Kentucky Transportation Cabinet Value Engineering Study

Mountain Parkway Item No. 10-166.00 Magoffin County

Value Engineering Study Report

Study Dates: May 23-25, 2016

SKETCH OF PROPOSED ASSUMPTION

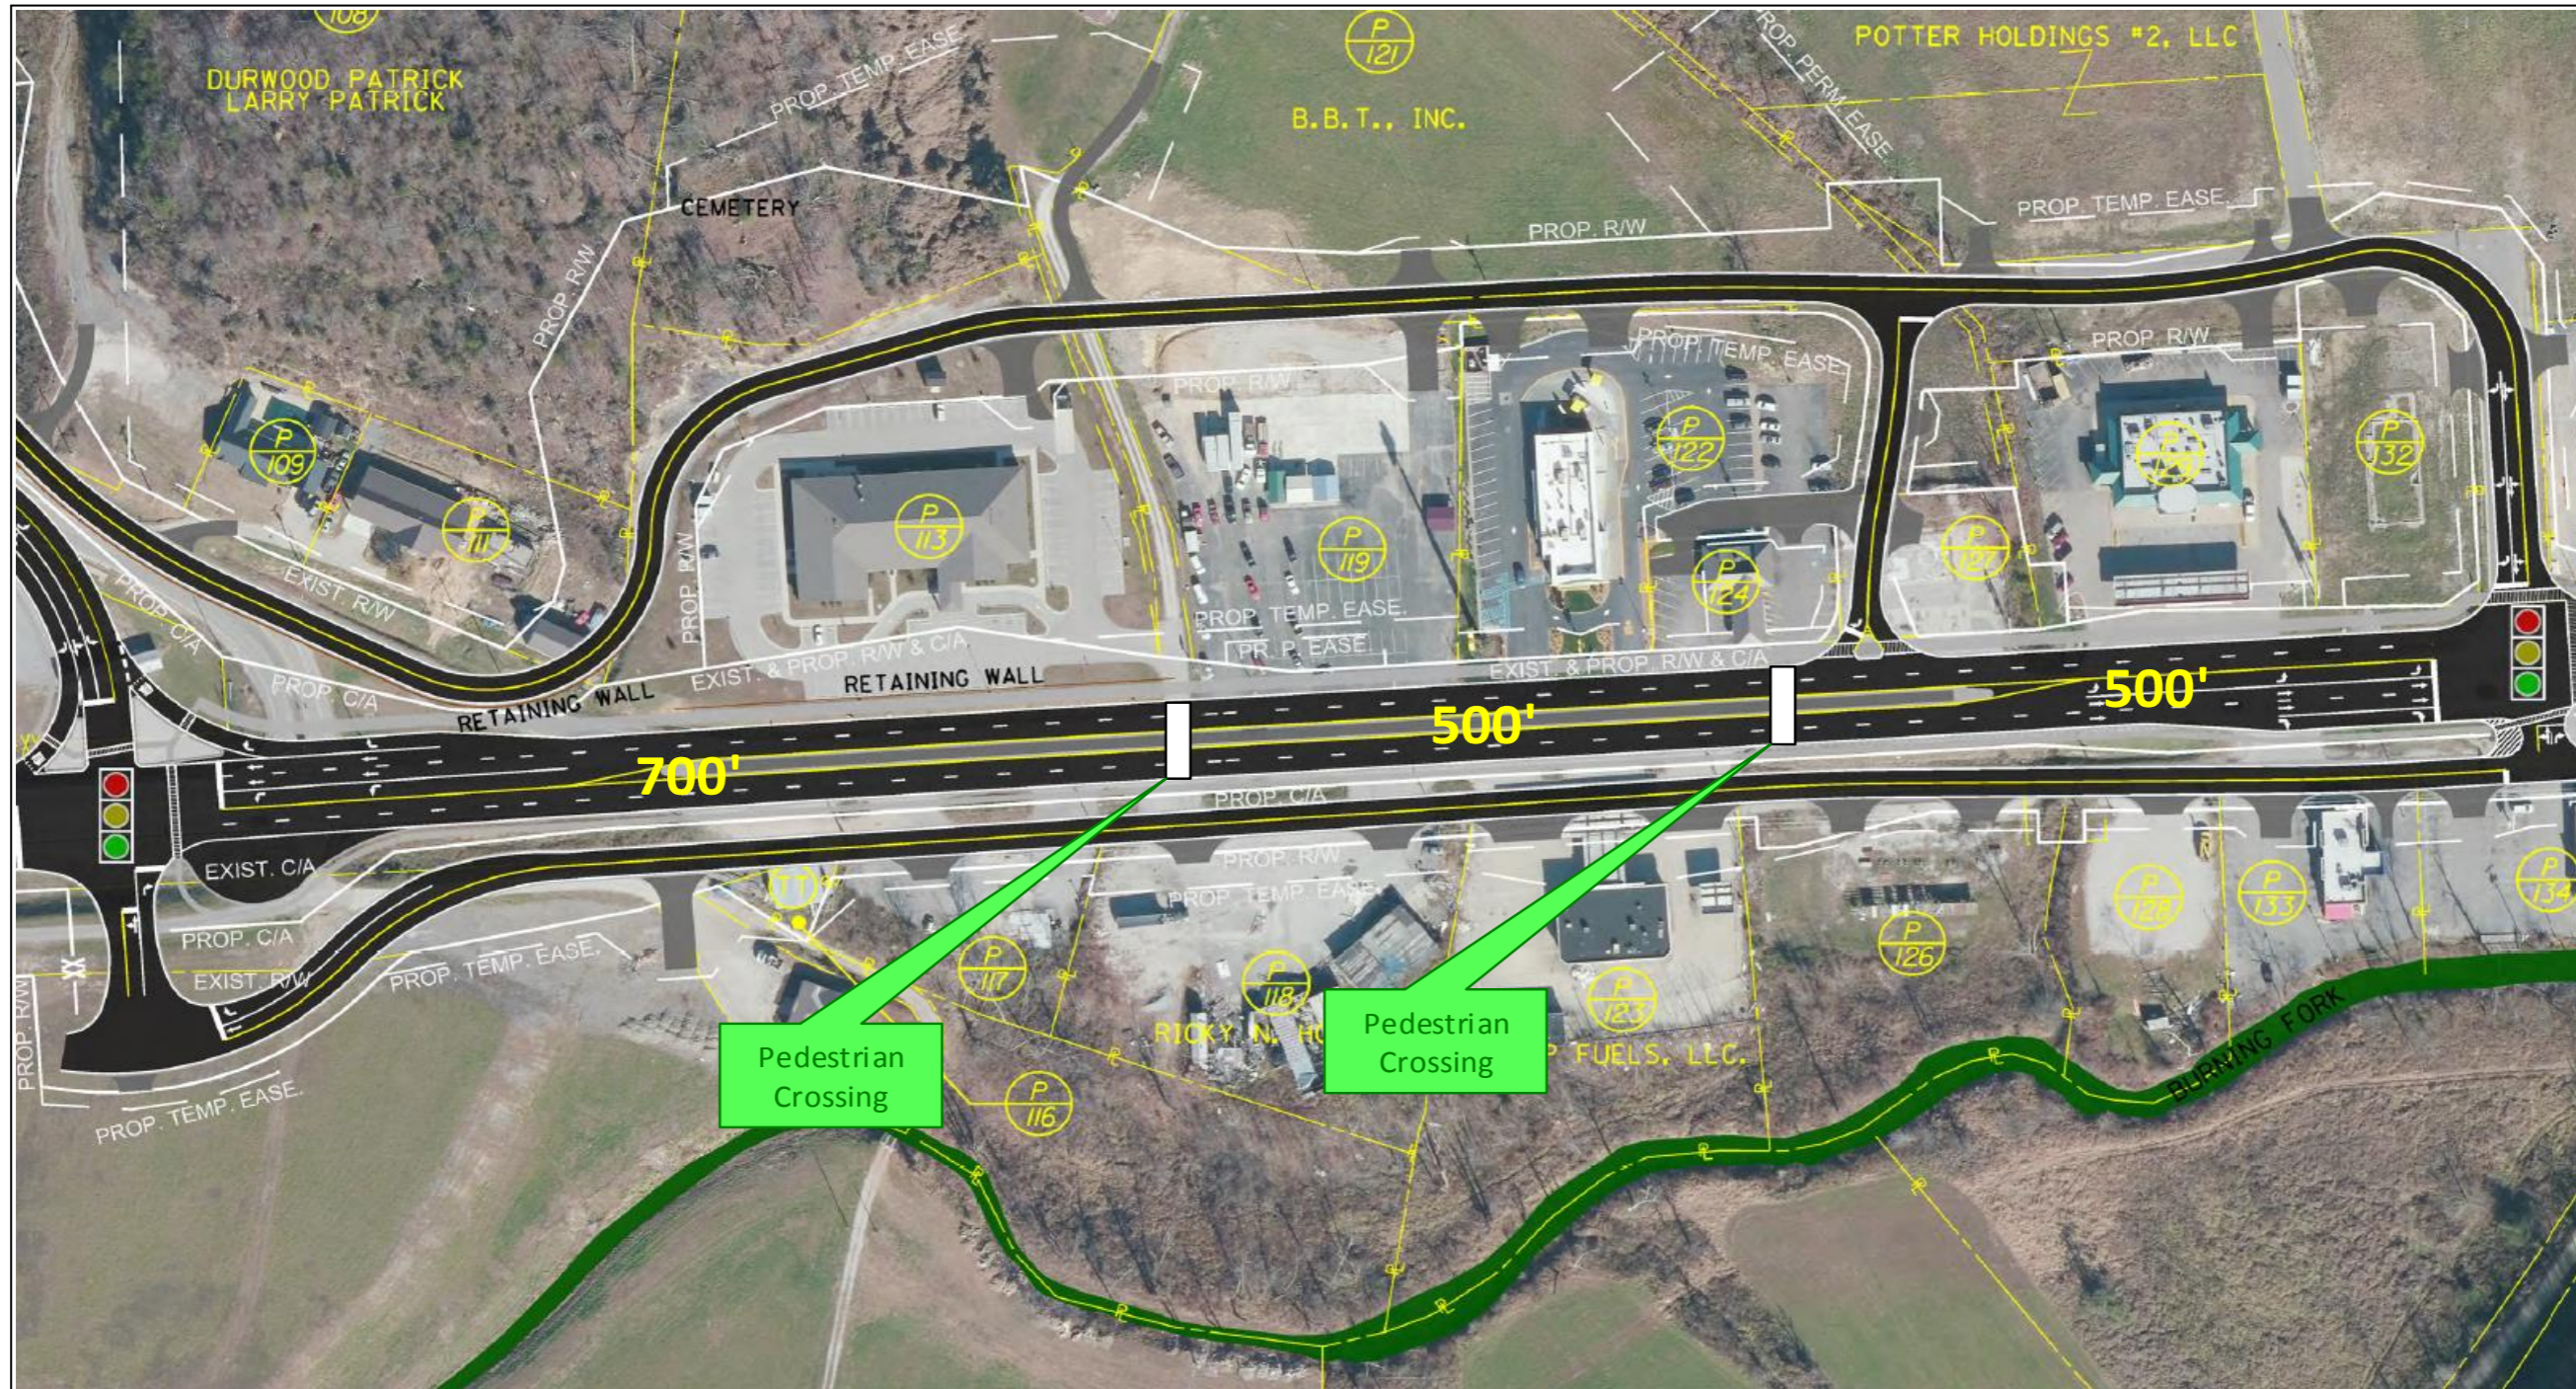
TITLE:	Add mid-block pedestrian crossings between traffic signals
DISCUSSION/JUSTIFICATION:	
<p>There are long distances separating crosswalks, currently only located at signalized intersections. Distances range from 1/3 to 2/3 of a mile. Research has shown that pedestrians will tend to take the shortest route possible unless there is a reasonable designated route within close proximity. Normally, it is best to space crossings between 300 and 800 feet apart.</p> <p>There are several opportunities for intermediate crossings along the corridor, especially in the western, more commercially developed portion. The subsequent diagrams show four possible locations that may make sense for natural pedestrian routes.</p> <p>Cutting through the raised median allows for an accessible and protected (refuge) area that pedestrians can make a two staged crossing.</p>	
IMPLEMENTATION CONSIDERATIONS:	
<p>The locations should be selected based on predicted travel patterns by pedestrians and at spacings that are reasonably short to minimize backtracking of the route. ADA ramp accommodations will be necessary. Whether to use crosswalk markings needs to be discussed and decided. Information will need to be added to the design plans, related to striping.</p> <p>Signalization or flashing beacons are not necessary but may be considered.</p>

VALUE ENGINEERING PROPOSAL MT-18
Kentucky Transportation Cabinet
Mountain Parkway Item No. 10-166.00

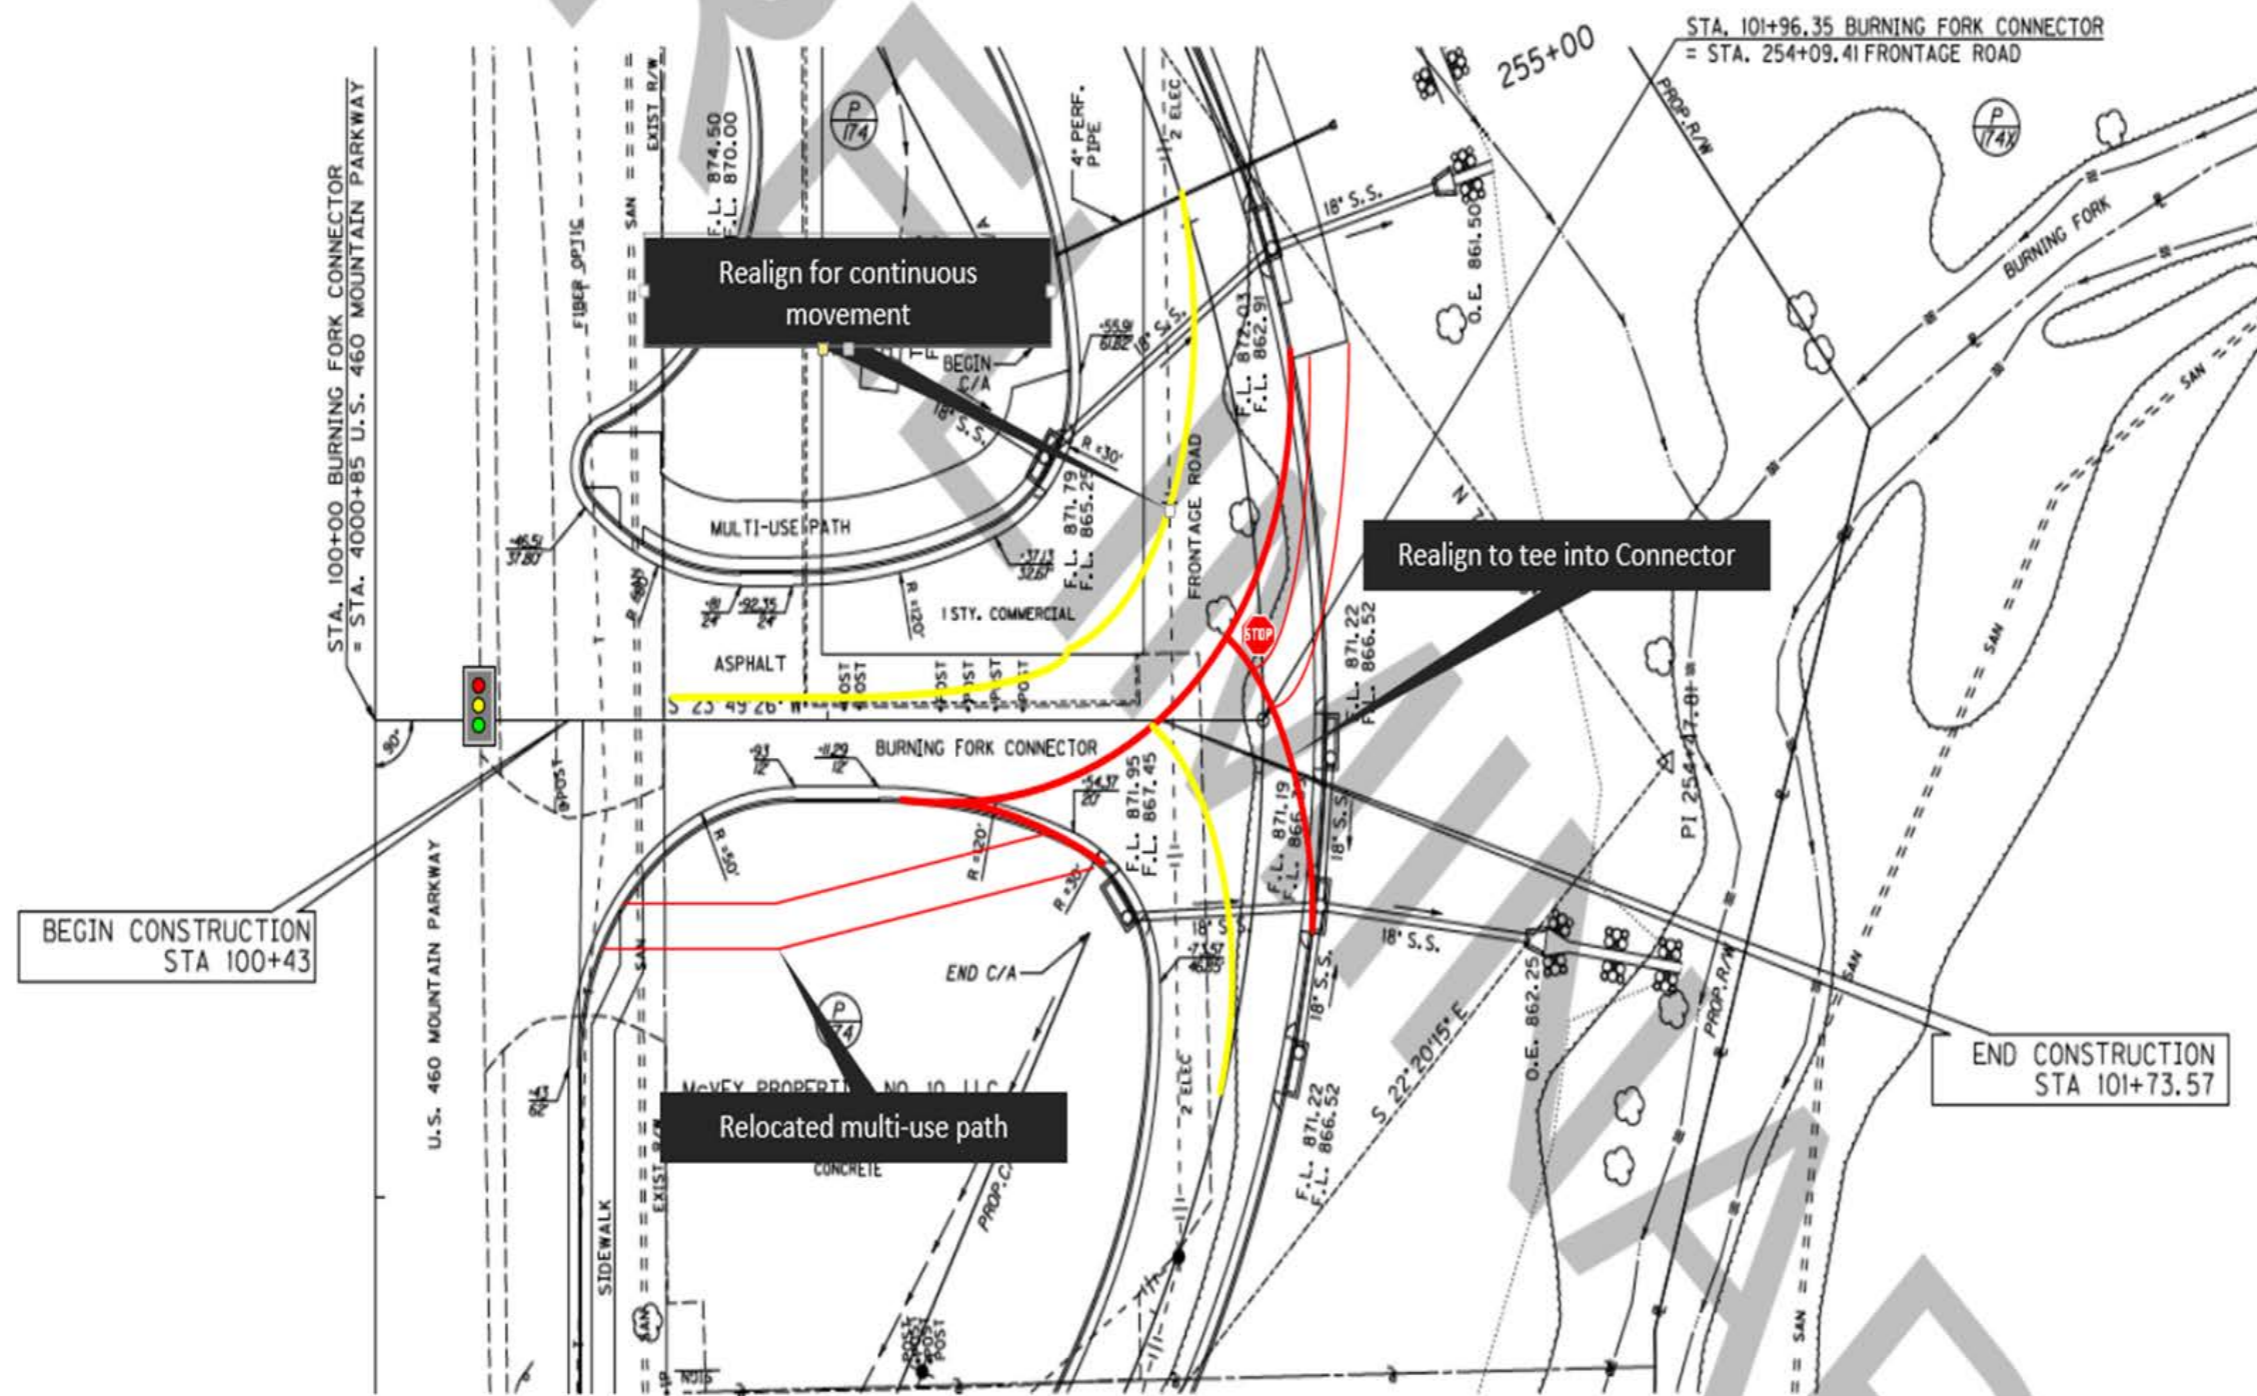
TITLE: Improve intersection at Burning Fork Connector and south frontage road
DISCUSSION/JUSTIFICATION: During peak school traffic periods, it will be important to facilitate efficient ingress and egress from the Parkway to the school. The current configuration will likely cause large backups coming from the school at the subject intersection because of the need to stop at the stop sign before proceeding to the traffic signal. By making the Connector and frontage road to the east continuous, the heavy movement of traffic coming from the school (east) will be able to more efficiently flow through the signal. The west leg of the frontage road will tee into the Connector and use a stop control. During off peaks, vehicles coming from the west should be able to find gaps to approach the Parkway intersection. During school times, drivers will be better served to go to the signalized intersection to the west to access the Parkway.

IMPLEMENTATION CONSIDERATIONS: Turning movements for the reconfigured intersection should be checked with the appropriate design vehicle. It appears that this change can be done without disruption to the current utility design and without purchasing new right-of-way. Additionally, the shared-use path will need to cross the Parkway on the west side of the intersection so that it is aligned to cross the frontage road at the stop sign. There appears to be no change in cost from the baseline to the proposed alternative.

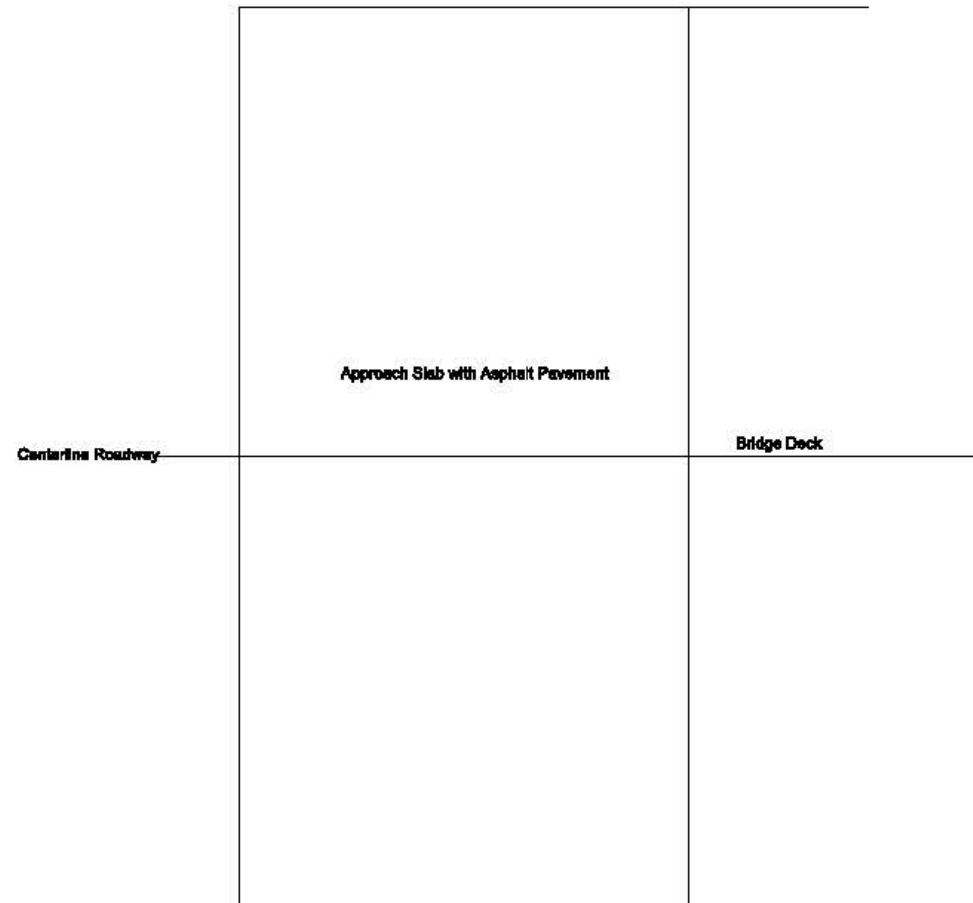
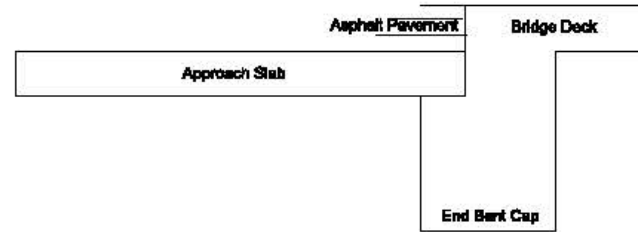
Over the past 15 years, there has been a tremendous amount of settlement at the end of bridges in District 10. This settlement creates a bump at the bridge end and requires asphalt maintenance on an annual basis. The approach slab bridges across any settlement that may occur and eliminates the bump. Asphalt pavement is placed on the slab ensuring a smooth transition onto the bridge. Research for the bump at the end of the bridge is currently underway. The study, Bridge End Settlement Evaluation and Prediction (SPR-14-436), utilizes available data for settlement at bridge ends to evaluate the best solution.

The approach slab will need to be designed and added to the bridge plans.

VALUE ENGINEERING PROPOSAL SS-03
Kentucky Transportation Cabinet
Mountain Parkway 10-166.00 Project

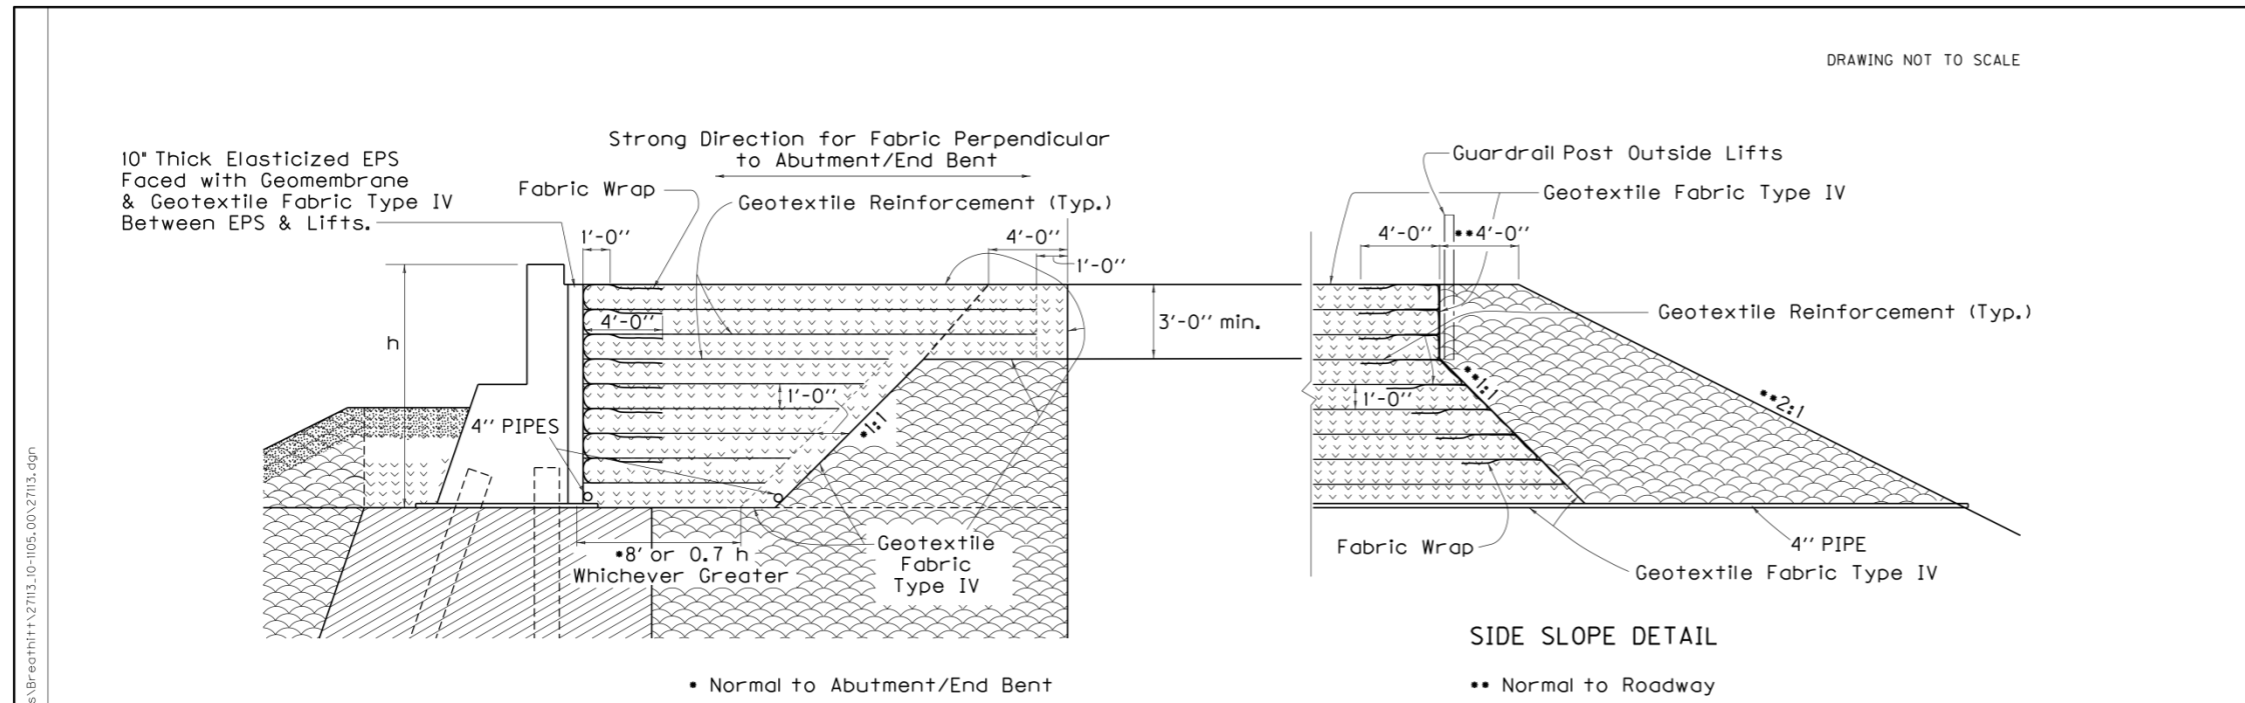
There needs to be a proactive approach to eliminate the "bump" at the ends of the bridge due to settlement of structural granular backfill. One approach used in District 10 in the past is to use reinforced backfill to minimize the granular backfill settlement. This alternate adds additional Structural Granular Backfill and Geotextile Fabric Type IV to the baseline condition. The proposed detail also adds Elasticized EPS membrane and High Strength Geotextile Fabric. The high strength geotextile fabric is placed at 1' lifts for the entire height of the end bent.

Alternate will cause modifications to plans and cost estimate.
